# Access Compliance Report

## Public Rights-of-Way

Intersection ID: 29190	Main Street: JADE_GLEN_DR	Cross Street: BIG_LEAF_DR	Location: NE
ADA ID: D1124C06B4CD	Ramp Type: PerpDiag	Initial Pass/Fail: Fail	Overall Compliance: No
		Severity Score: 12.5

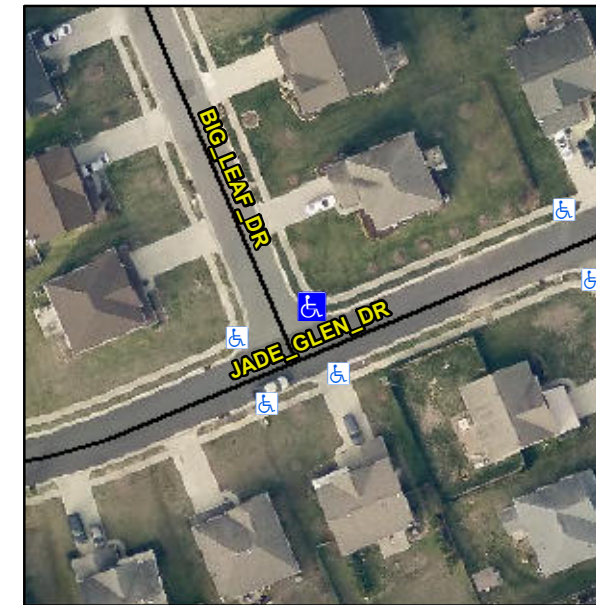
**Not Found, R304.5.3**

Compliance	Description	Data	Compliance	Description	Data
N/A	Ramp Length (in)	48.0	Yes	Ramp Slope (%)	5.5
Yes	Ramp Width (in)	48.0	No	Ramp XSlope (%)	5.1
N/A	Flare Type LT	N/A	N/A	Flare Type RT	N/A
N/A	Flare Slope LT (%)	N/A	N/A	Flare Slope RT (%)	N/A
N/A	Flare Traversable LT?	N/A	N/A	Flare Traversable RT?	N/A
N/A	Landing Length (in)	N/A	N/A	DWS Provided?	N/A
N/A	Landing Width (in)	N/A	N/A	DWS Contrast?	N/A
N/A	Landing Slope (%)	N/A	N/A	DWS Length (in)	N/A
N/A	Landing X Slope (%)	N/A	N/A	DWS Full Width?	N/A
N/A	Landing Curb? (Y/N)	N/A	N/A	DWS Offset (in)	N/A
N/A	Shared Landing?	N/A			
N/A	Gutter Ponding?	N/A	N/A	Gutter Slope (%)	N/A
N/A	Gutter Lip Ht (in)	N/A	N/A	Gutter X Slope (%)	N/A
N/A	Painted X Walk1?	No	N/A	Painted X Walk2?	No
	X Walk 1 Direction	To W		X Walk 2 Direction	To S
N/A	X Walk 1 Width (in)	N/A	N/A	X Walk 2 Width (in)	N/A
	X Walk 1 Slope (%)	1.4		X Walk 2 Slope (%)	3.5
	X Walk 1 X Slope (%)	2.4		X Walk 2 X Slope (%)	1.1

**Remove & Replace Curb Ramp With Two New Directional Ramps or Equivalent.**
